Technical Service BULLETIN

REAR HATCH SLOW TO OPEN

'03 – '07 Matrix

BODY
B0009-07

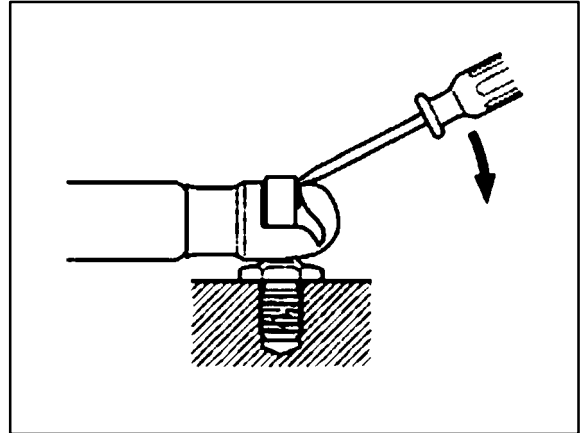
- Use the same procedures for the RH side and LH side.
- Perform Removal and Installation steps for one side at a time.
- Tape the screwdriver tip before use.

Remove the back door stay assembly

1. Using a screwdriver, remove the stay clip from the stay up side.
2. Using a screwdriver, remove the stay clip from the stay lower side.

While supporting the back door with your hand, remove the back door stay.

1. Install the back door stay assembly with the 2 stay clips.
2. Repeat the removal and installation steps for the opposite side.
3. Verify the back door opens and closes properly, once both back door stay assemblies have been installed.

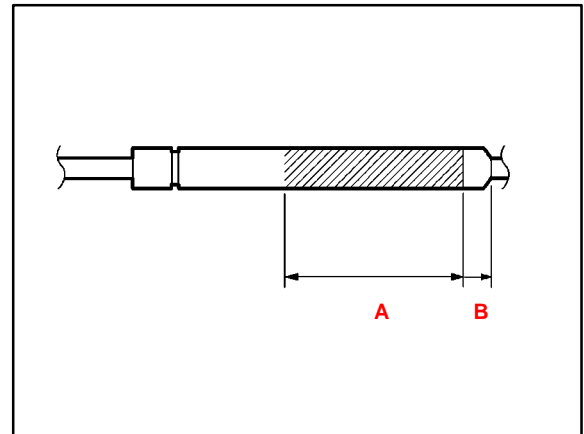
Release the gas charge in the old stay assemblies by following this procedure.

1. Horizontally mount the stay in a vise with the rod pulled out.
2. Wearing safety glasses, slowly release the gas charge by gradually cutting a hole (using a metal saw blade) in the stay body area marked "A" in the illustration to the right.

A	80 mm (3.15 in.)
B	20 mm (0.80 in.)
